**ORIGINATION FORM**

**Proposed Revisions to a Standard Plans Index**  
(Please provide all information — Incomplete forms will be returned)

Index Number: 515-080

Index Title: Pipe Guiderail (Steel)

TYPICAL SECTION ON CONCRETE SIDEWALK

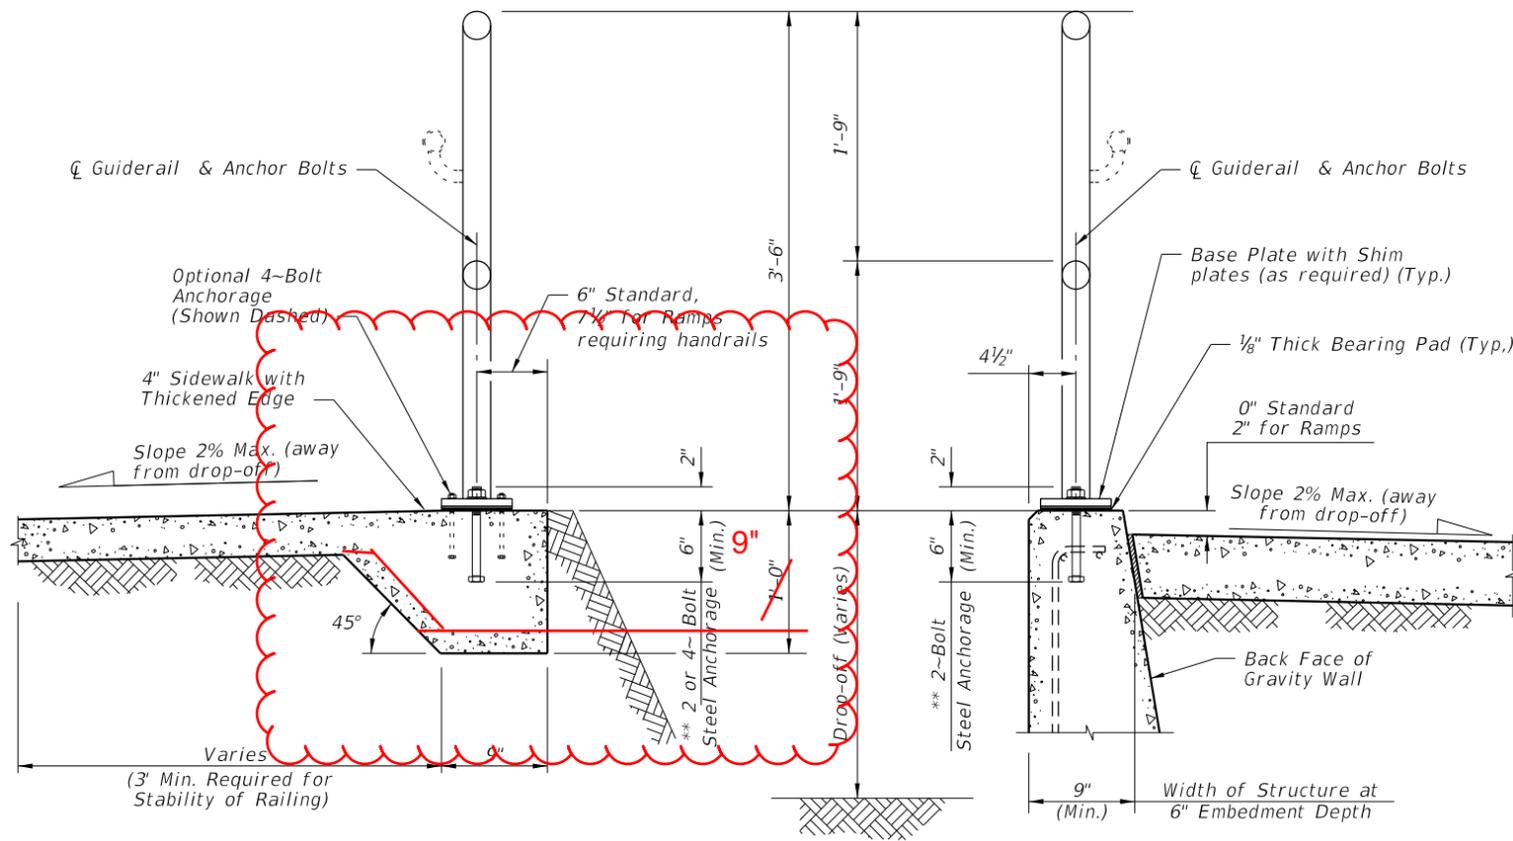
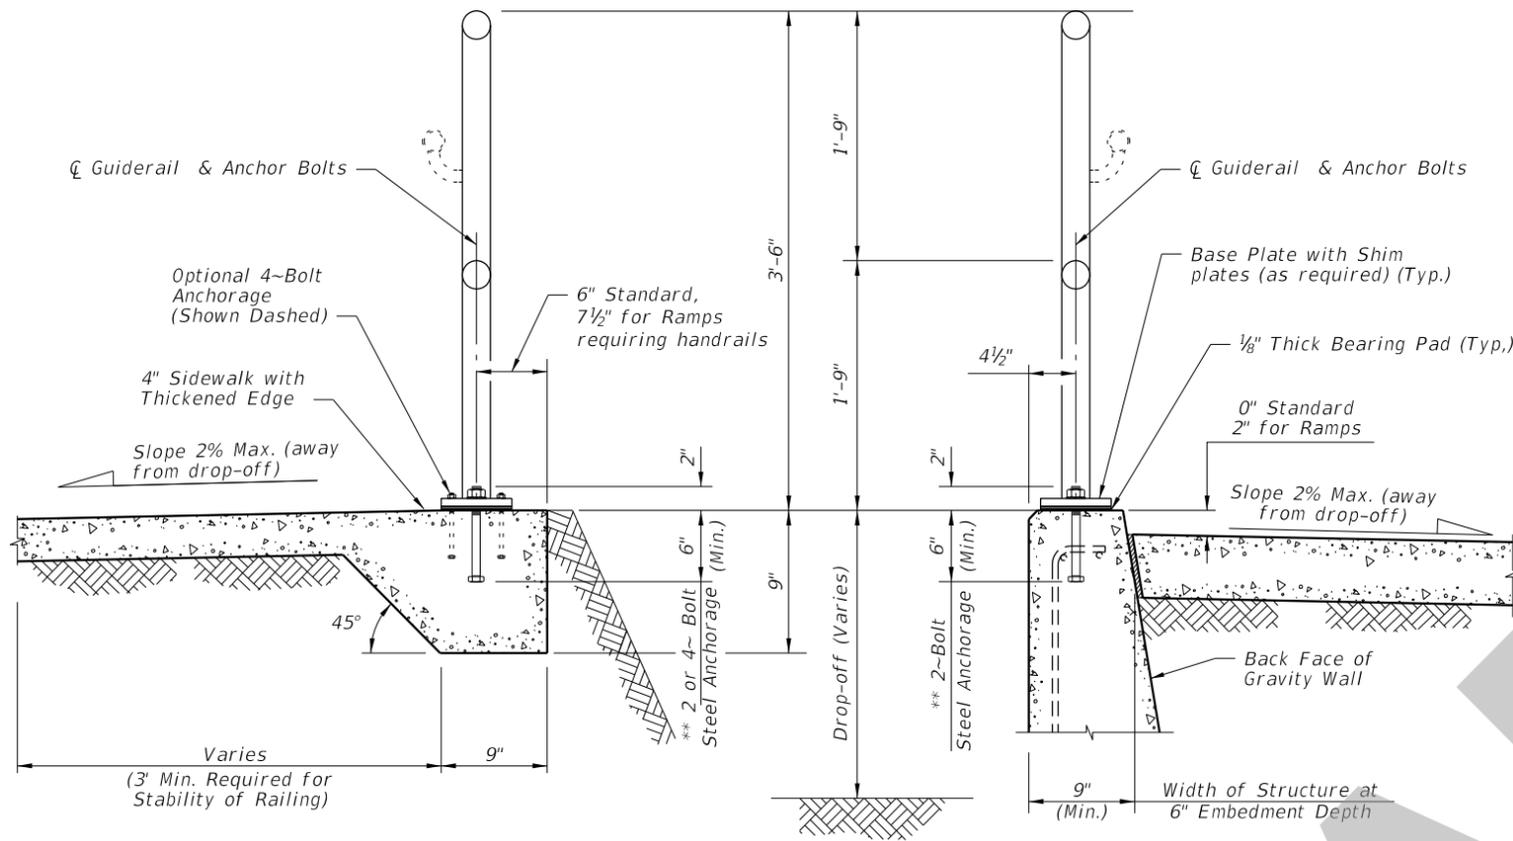
Change edge beam of sidewalk to 9" deep.

Due to research, embedment was reduced to 6"; therefore, the depth can be reduced to 9".
